ATTACHMENT TO IPN-99-082  
SAFETY EVALUATION FROM SUBMITTAL IPN-99-015

NEW YORK POWER AUTHORITY  
INDIAN POINT 3 NUCLEAR POWER PLANT  
DOCKET NO. 50-286  
DPR-64

SAFETY EVALUATION OF TECHNICAL SPECIFICATION CHANGES REGARDING  
CONTROL ROD MISALIGNMENT AND ROD POSITION INDICATION

Figure 3.10-1

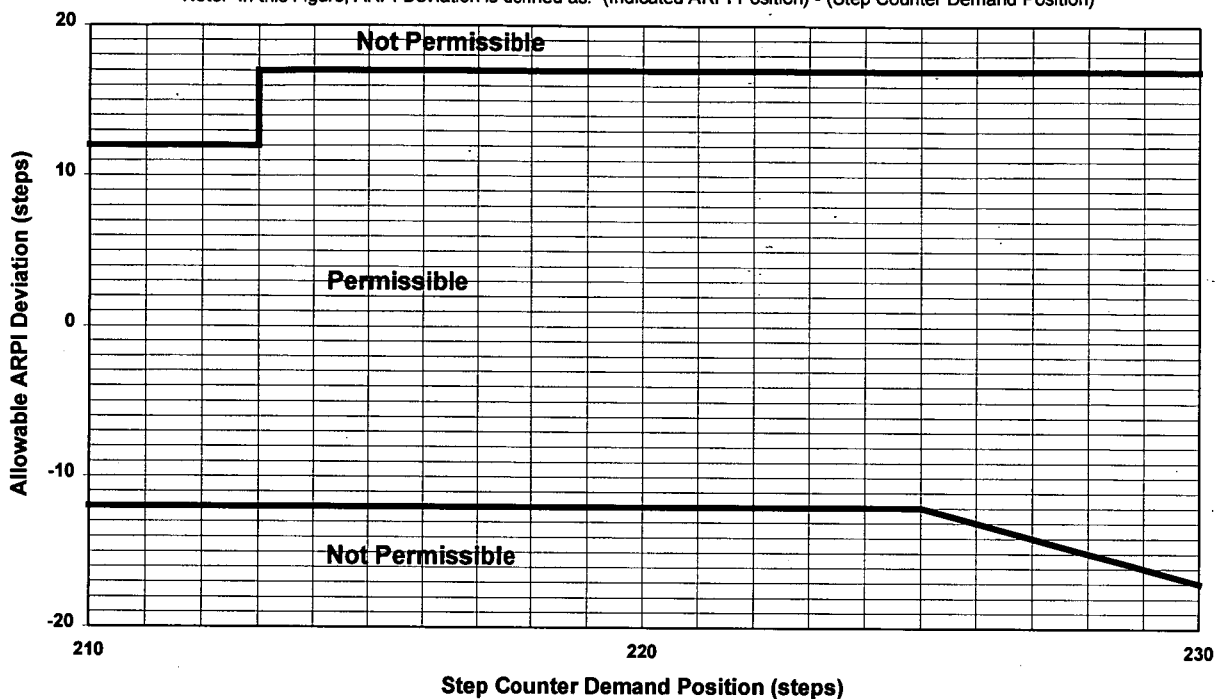
- b. For operation greater than 85% of rated thermal power, the indicated misalignment between the group step counter demand position and the analog rod position indicator for each control or shutdown rod shall be within the limits of Figure 3.10-1. ~~This allowable deviation may be increased by up to an additional six steps (indicated on Table 3.10-1) as a function of peaking factor margin  $F_p(Z)$  and  $F_{\Delta H}^N$ .~~ A control or shutdown rod indicating a misalignment greater than that allowed by this specification shall be realigned within one hour or the core peaking factors shall be determined within two hours and the requirements of Specification 3.10.2 applied.

- a)  $\pm 24$  steps of the group step counter demand position (if the power level is less than or equal to 85% of rated thermal power);
- b) to within the varying allowable deviations shown in Figure 3.10-1 for power level greater than 85% of rated thermal power. ~~This may be extended up to an additional six steps in either direction if sufficient peaking factor margin exists;~~

For group step counter demand positions greater than 212 steps withdrawn, it is acceptable for the analog rod position indicator to indicate misalignment greater than +12 steps (as indicated on Figure 3.10-1) ~~without accounting for peaking factor margin.~~ This is due to the top of active fuel stack being at approximately 225 steps withdrawn. Indicated misalignment in the more withdrawn direction should result in the actual rod position being no lower than 201 steps withdrawn (which is within the analyzed limits). Actual control rod positions above the top of active fuel will not result in increased peaking factors for increased

Add Figure 3.10-1, Permissible Rod Misalignment vs. Step Counter Demand Position, >85% Of Rated Thermal Power

- b. For operation greater than 85% of rated thermal power, the indicated misalignment between the group step counter demand position and the analog rod position indicator for each control or shutdown rod shall be within the limits of Figure 3.10-1. A control or shutdown rod indicating a misalignment greater than that allowed by this specification shall be realigned within one hour or the core peaking factors shall be determined within two hours and the requirements of Specification 3.10.2 applied.

- a)  $\pm 24$  steps of the group step counter demand position (if the power level is less than or equal to 85% of rated thermal power);
- b) to within the varying allowable deviations shown in Figure 3.10-1 for power level greater than 85% of rated thermal power.

The allowable deviation shown in Figure 3.10-1 varies as a function of bank demand position allowing for the top of active fuel ending at a control rod position of approximately 225 steps.

For group step counter demand positions greater than 212 steps withdrawn, it is acceptable for the analog rod position indicator to indicate misalignment greater than +12 steps (as indicated on Figure 3.10-1). This is due to the top of active fuel stack being at approximately 225 steps withdrawn. Indicated misalignment in the more withdrawn direction should result in the actual rod position being no lower than 201 steps withdrawn (which is within the analyzed limits). Actual control rod positions above the top of active fuel will not result in increased peaking factors for increased misalignments. Similarly, allowable negative deviation limits may increase by 1 step for every step of group step counter demand position over the top of active fuel.
